Re: Runstad Beach House, Blakely Island – Stormwater Site Plan Addendum

STORMWATER SITE PLAN
ADDENDUM

RUNSTAD BEACH HOUSE

STORMWATER SITE PLAN – ADDENDUM

FIGURE 1

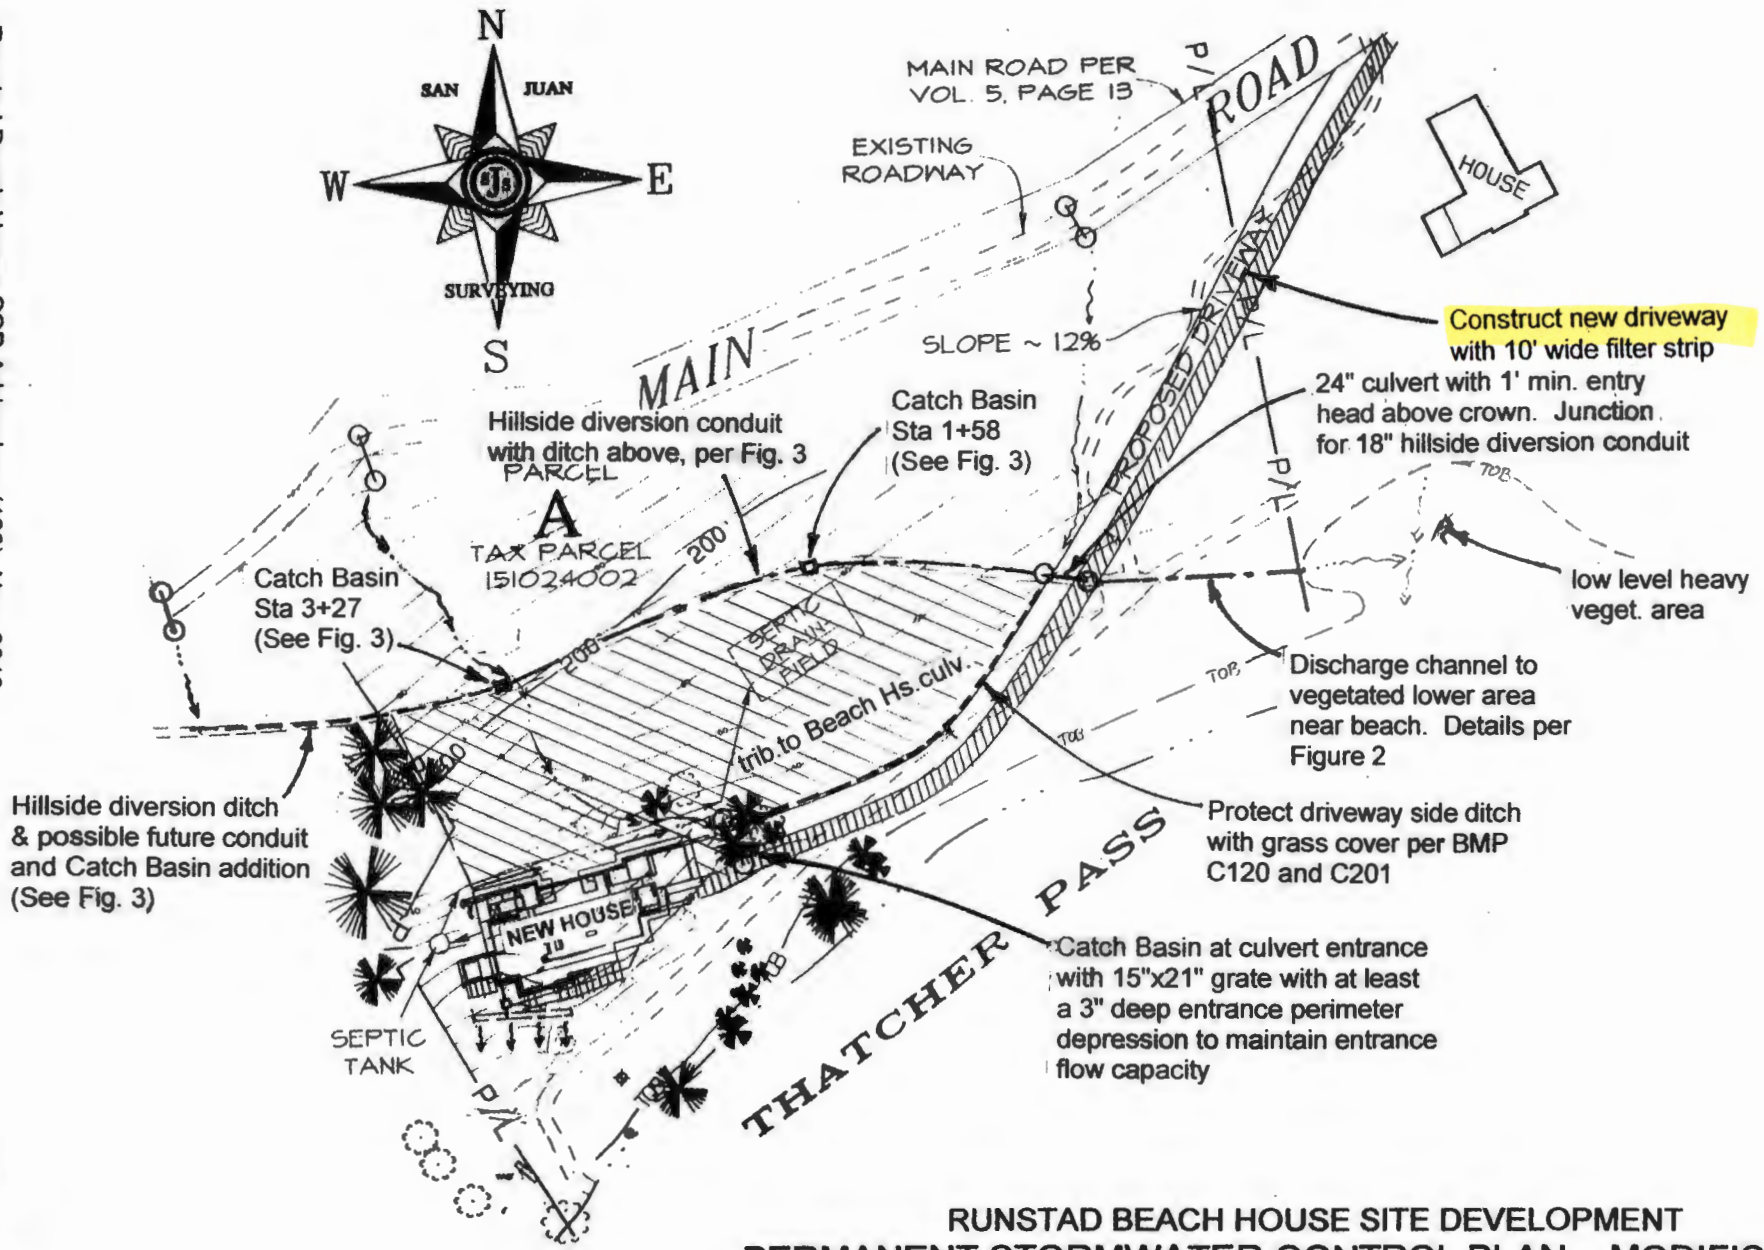
Analysis of the ongoing erosion and sediment problem in late February 2011 resulted in design of a closed conduit diversion system along the hillside pathway with a primary inlet basin at the seasonal channel location above the Beach House and additional local flow ditch capture beyond (west) of this structure and routed to an additional intermediate catch basin location farther down the path. The objective was to keep ditch flow low enough with the conduit that a stable vegetated channel could be provided here that will effectively maintain both flow control and hillside erosion protection. This system has been in place since the latter part of last season and into the current runoff season, with a well-vegetated ditch along the pathway that has effectively stabilized conditions on this hillside area above the Beach House.

The design of the conduit system included an upper-end catch basin that could be added if flows from the upper end road culvert appeared to be sufficient that ditch erosion becomes evident. (It should be noted that groundwater discharge from the hillside above is predominant enough that reliable surface flow hydrologic modeling to predict flows from each road culvert is difficult.) Photos of the current conditions along the pathway ditch and at the main discharge channel to the shore are included in the appendix.

Note that the extent of diversion improvements made during construction along the hillside pathway was extensive enough that they can be considered effective as part of the permanent stormwater control system for the Beach House. Modeling of tributary flow toward the Beach House culvert with this diversion system in place drastically reduces design flows there to the extent that a grate-top catch basin can effectively handle inflow and the culvert and discharge rock protection originally specified and constructed is far in excess of what will now be required for conditions here.

The approximately 4,000 sq. ft. of additional disturbed area for construction of the added features described above changes the originally-estimated area to 29,000 sq. ft. (0.666 ac.), still well below the DOE 3/4 acre threshold for native land conversion.

FIGURE 2

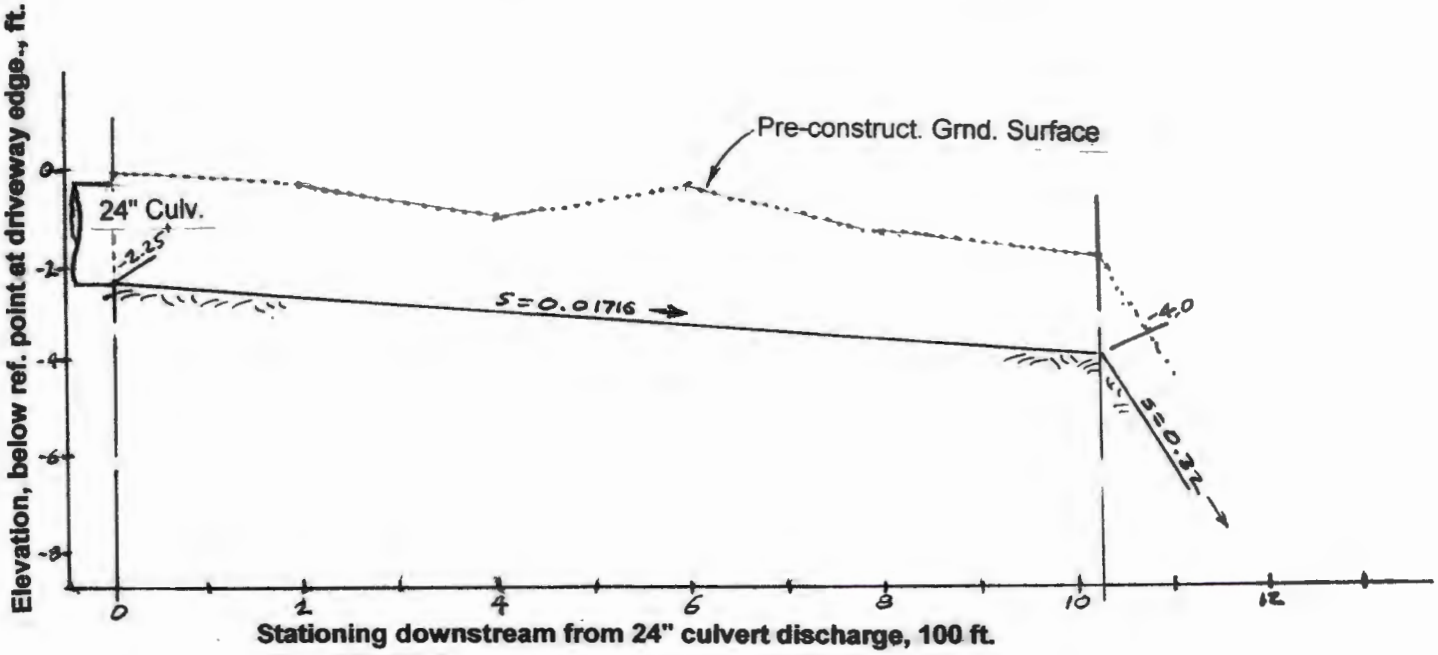
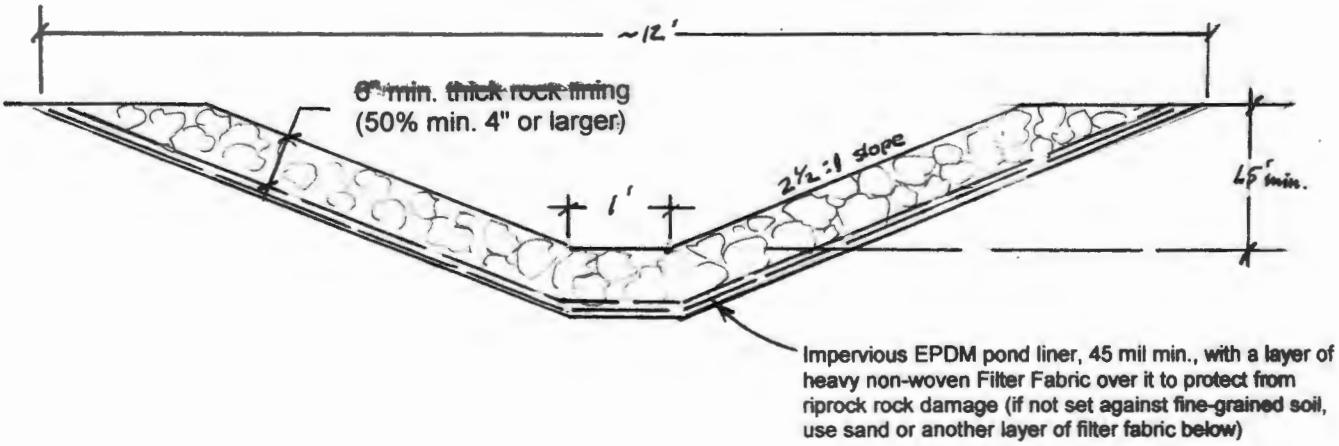
The combined diversion outflow at the enlarged 24" diam. upper driveway culvert location was routed into a rock and membrane-lined discharge channel to dissipate energy and carry flow into the heavily-vegetated low area near the shoreline farther to the east. This avoided discharge at the more conventional steep bank location that has existed along the historic driveway ditch alignment, and the membrane liner helps assure that discharge flows will not saturate the adjacent steep shoreline bank and further contribute to sloughing. Design for this facility is indicated in Figure 2. Hydraulic analysis of the channel using Manning's Formula (copy in appendix) indicated that a 100-yr peak flow of 20.55 c.f.s. (conservative est. based on combined original drainage flow peaks of 11.34 and 9.21 c.f.s. and ignoring the fact that 0.85 ac. below the hillside diversion is still routed to the Beach House culvert) would have a max. flow depth in the 1 ft. bottom width 1.716% slope rock-lined channel of 1.59 ft. with a peak velocity of 4.69 fps. The slope below this initial 102 ft. of main channel steepens down the hillside to the low vegetated area at approx. 32%, but the ditch bottom width is increased to 2 ft. and flow depth decreases to 0.48 ft. with a peak flow velocity of 13.4 fps – necessitating a max. riprap size increase to 8-inches. Entrance conditions at the upper end of the culvert (and junction with the hillside diversion conduit) necessitated a minimum available head at least 1 ft. above the crown of the culvert. Peak flows occur over very short periods and performance over more than 1.5 years has continued to maintain a stable condition in the heavily vegetated low area that receives discharge (see photos in appendix).

- On steep slope below main channel, pond liner can be eliminated. Widen bottom width to 2 ft. and make 50% of rock 8" or larger (10" min. layer).
- All rock shall be hard, durable, angular rock

FIGURE 3

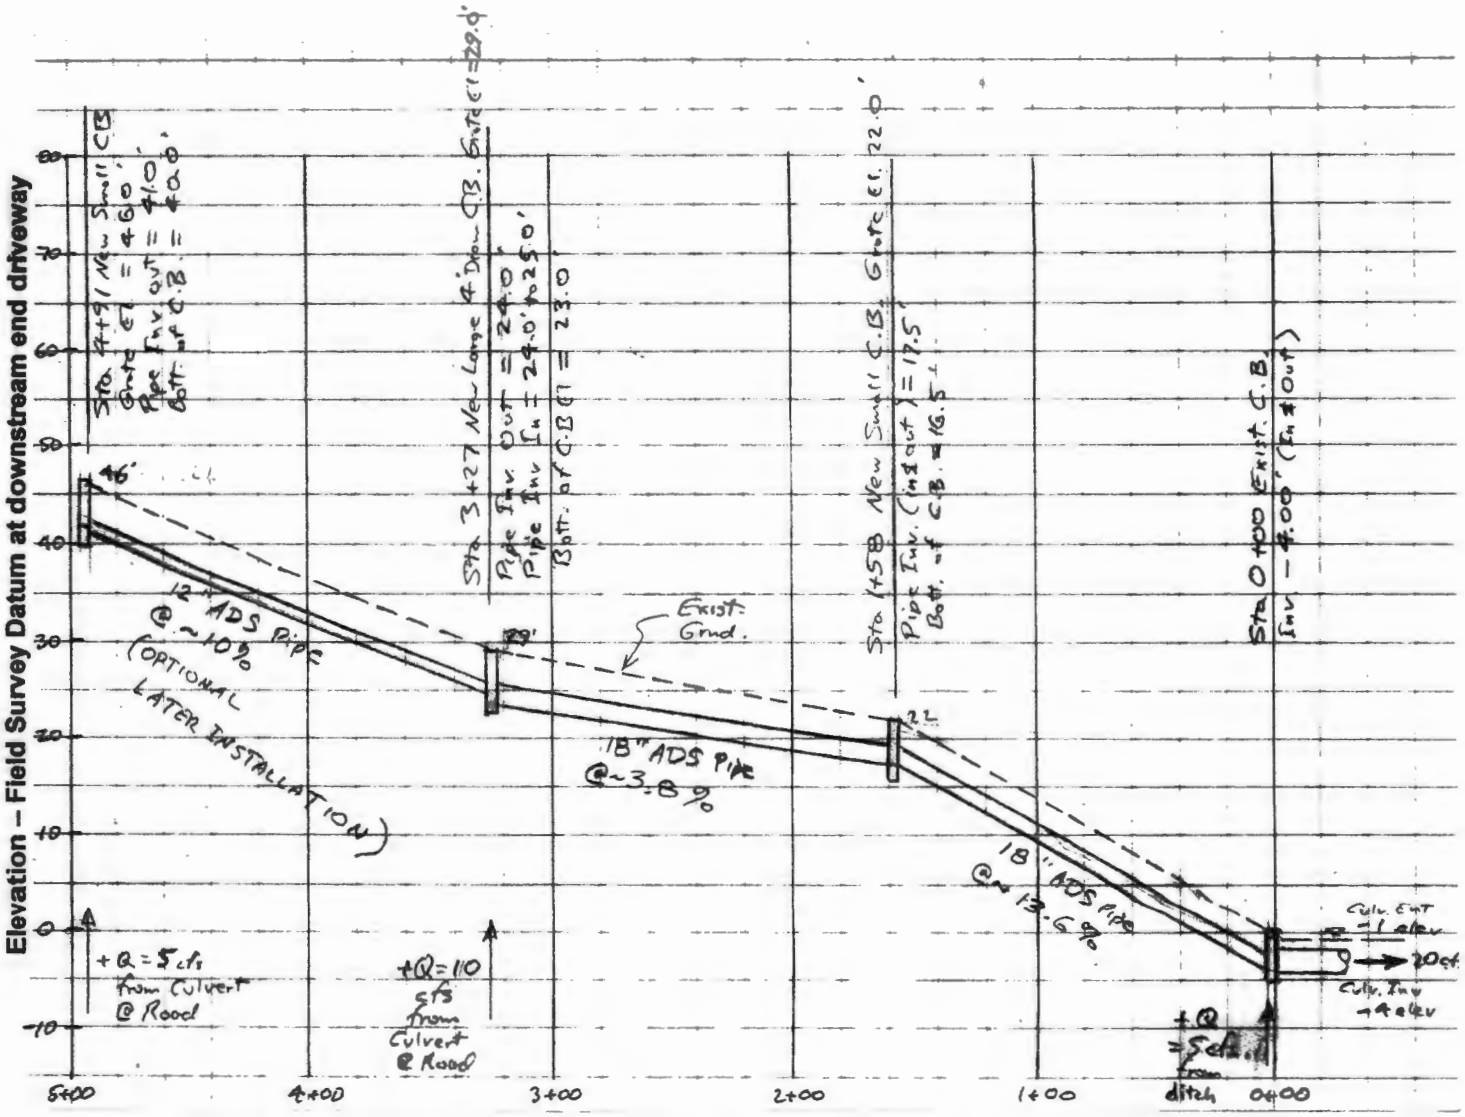
The closed conduit hillside diversion along the old pathway alignment greatly reduces runoff in the channel alignment to the Beach House site, as indicated in Figure 1. This system was designed using flow analysis based on Manning's Formula analysis of part-full pipe flow and considering need to accommodate velocity head at catch basin inlets to assure the system can handle inflow (copy of analysis in appendix). Results of the design are presented in Figure 3. The effectiveness of the diversion "ditch" created by the historic pathway has been maintained to capture local runoff from the hillside above and route it to catch basin locations along the diversion alignment. The objective was to restrict ditch flow to local input such that stable vegetative cover could be maintained. It was

further determined that the upper-end catch basin (below a road culvert west of the other two of primary concern) could be added at a later date, if necessary to avoid erosive flows in the surface ditch initially provided along the existing pathway. The operational history of this completed facility since the latter part of the past rainy season and beginning of the current season is very encouraging, with well vegetated and stable cover that suggests the system is operating as anticipated (photos in appendix).
